March 25, 2020

RE: *Continued Public Hearing - **Mill Plaza Redevelopment**. 7 Mill Road. Continued review of formal application for: 1) Site plan and 2) Conditional Use for mixed use redevelopment project and activity within the wetland and shoreland overlay districts. A revised general layout has been submitted for review. Colonial Durham Associates, property owner. Sean McCauley, agent. Joe Persechino, Tighe & Bond, engineer. Ari Pollack, attorney. (Rick Taintor is serving as the Town's Contract Planner.) Central Business District. Map 5, Lot 1-1.*

What is counted in the table on Sheet C-701 of the Plan?

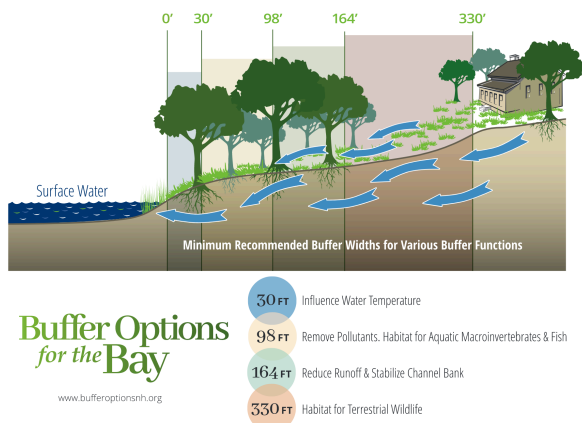
1) Why is there really only one area of decreased shoreland and wetland buffer?

- Are the pervious parking lot islands (a good low impact development measure) included in the calculations of change to the wetland or shoreland buffers?
